ORIGINATION FORM

Proposed Revisions to a Standard Plans Index
(Please provide all information — Incomplete forms will be returned)

Index Number: 400-010

Index Title: Cantilever Retaining Wall

LAST REVISION 11/01/17	REVISION	DESCRIPTION:		FY 2020-21 STANDARD PLANS	CANTILEVER RETAINING WALL (C-I-P)	INDEX 400-010	SHEET 1 of 2
---------------------------	----------	--------------	---	------------------------------	-----------------------------------	------------------	-----------------

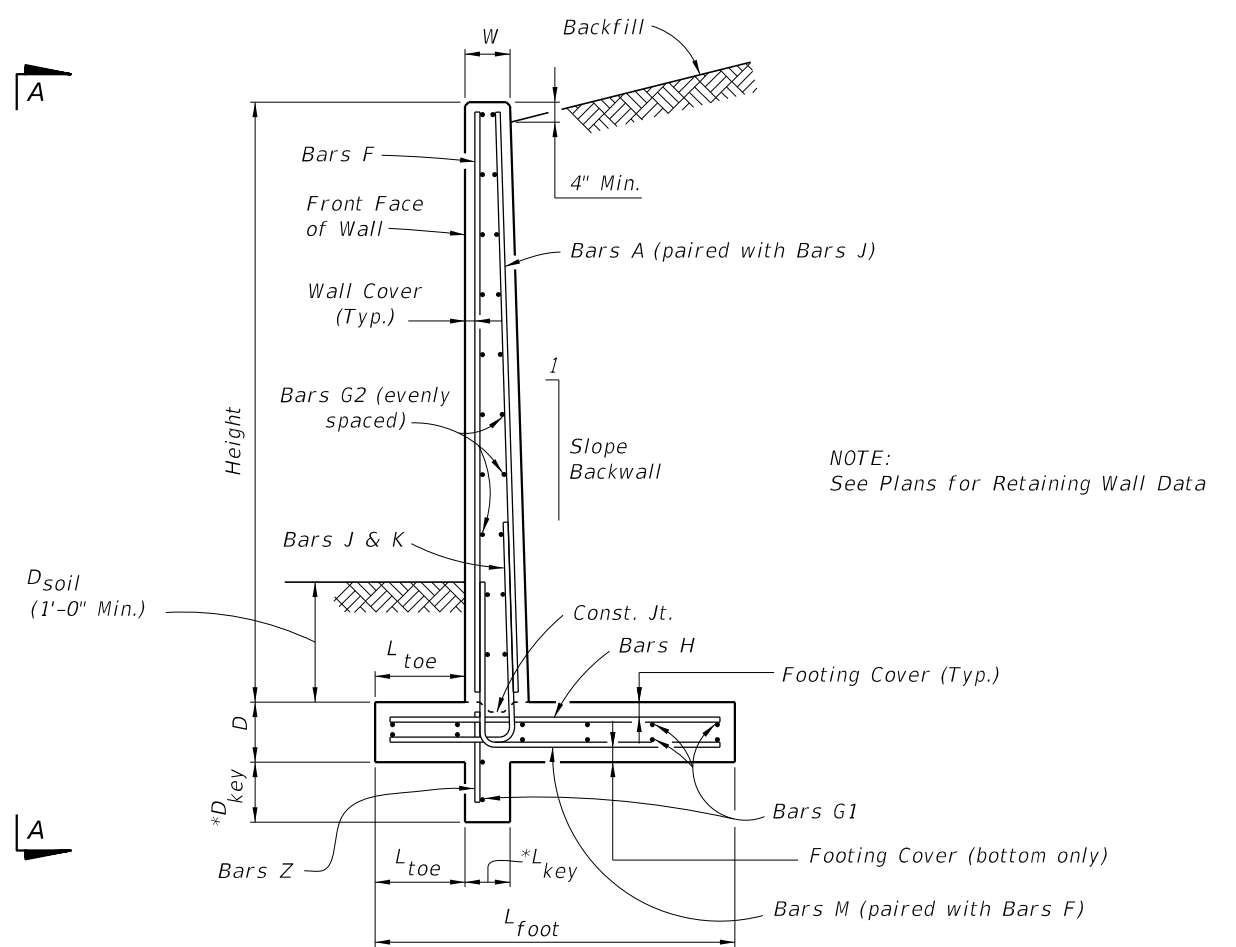
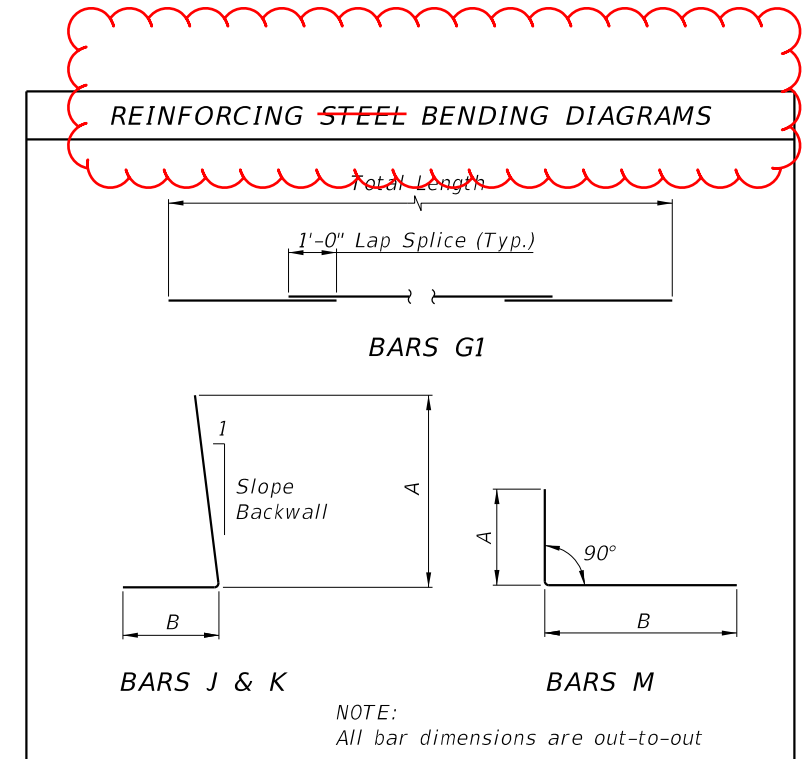
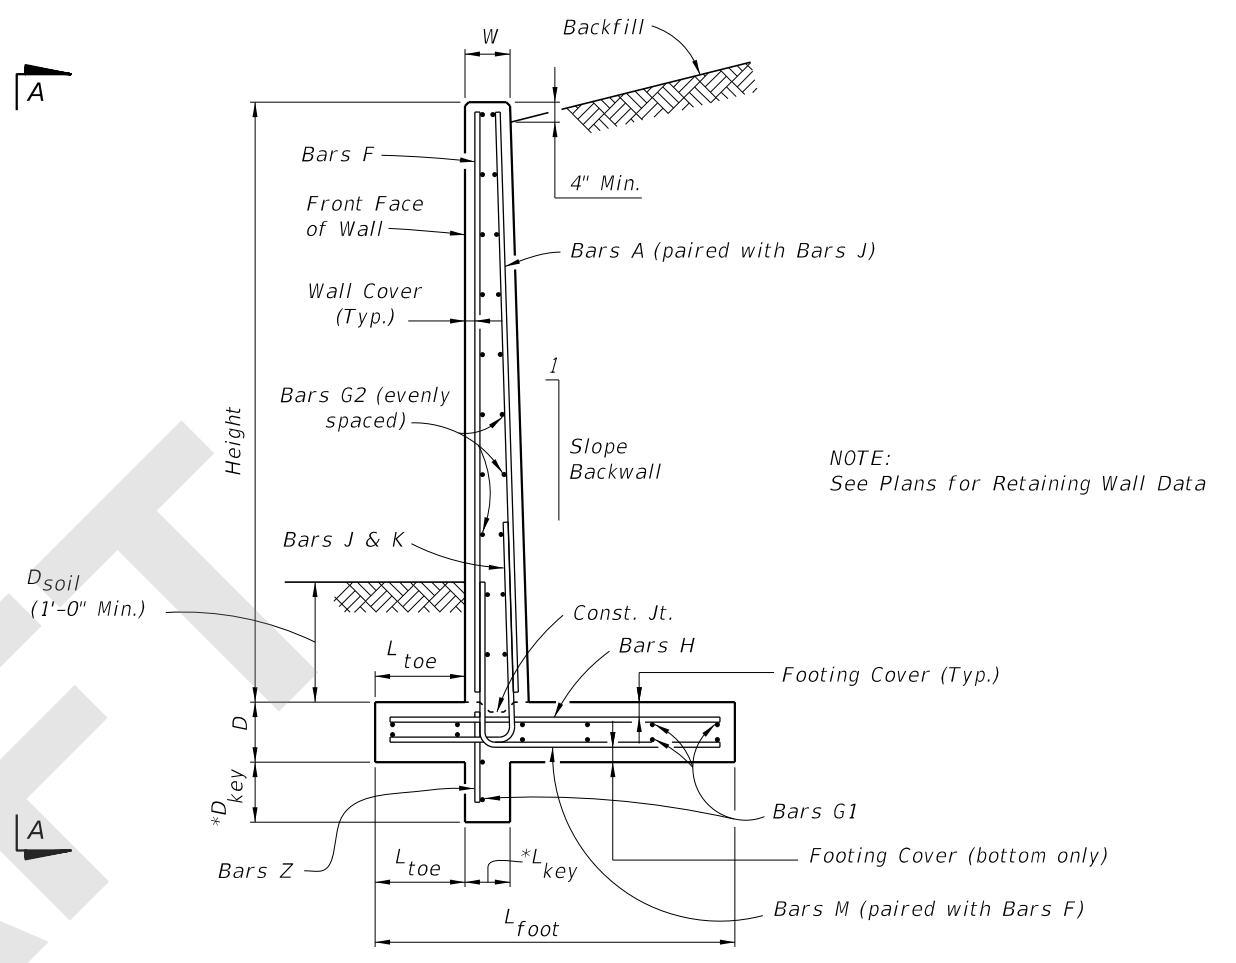
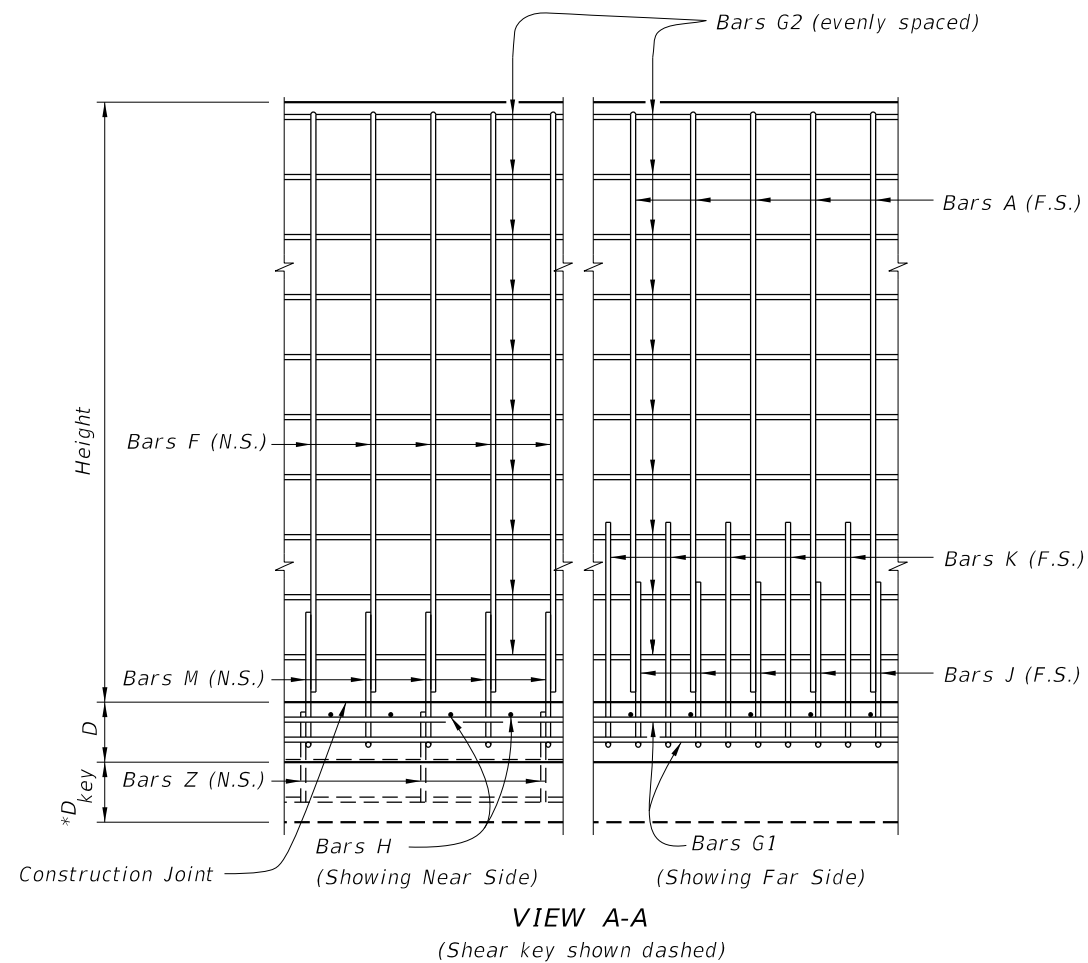
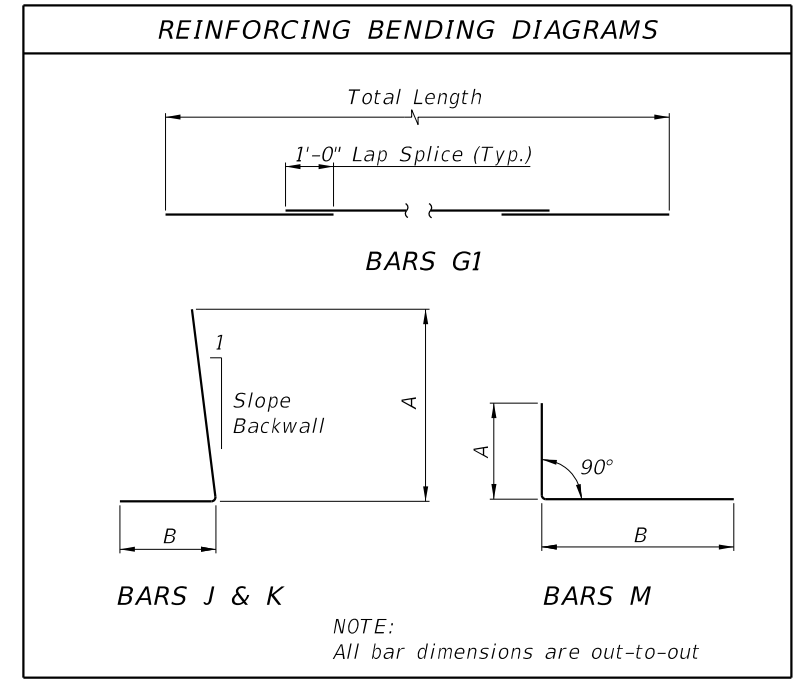
Remove reference to steel for reinforcement

Make generic for Steel or GFRP/BFRP reinforcing

SECTION A-A
EXPANSION JOINT DETAIL

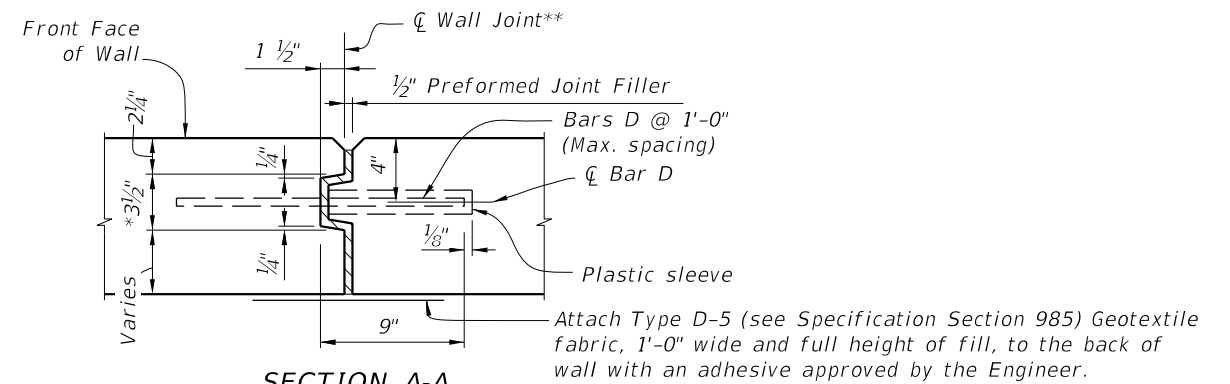
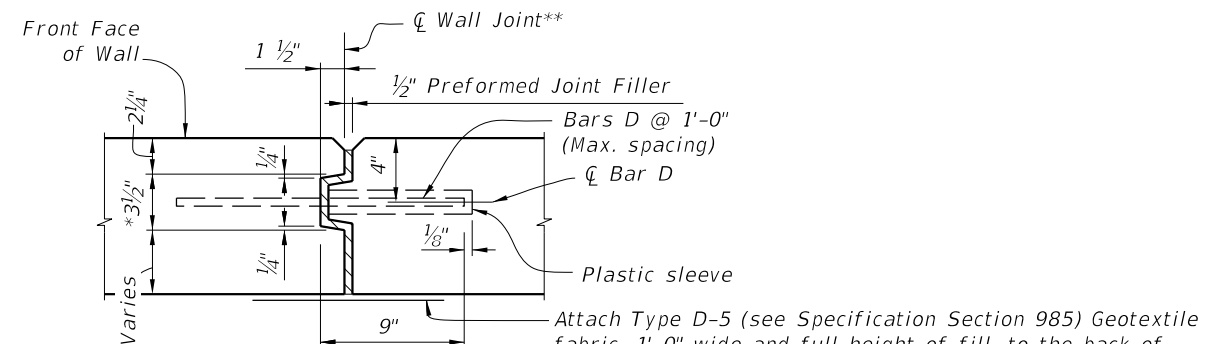
*** Bars D: Where a bend is required to maintain clearances, submit bend angle to GFRP supplier; steel reinforcing may be field bent.

*** Bars D: Where a bend is required to maintain clearances, submit bend angle to GFRP supplier; steel reinforcing may be field bent.
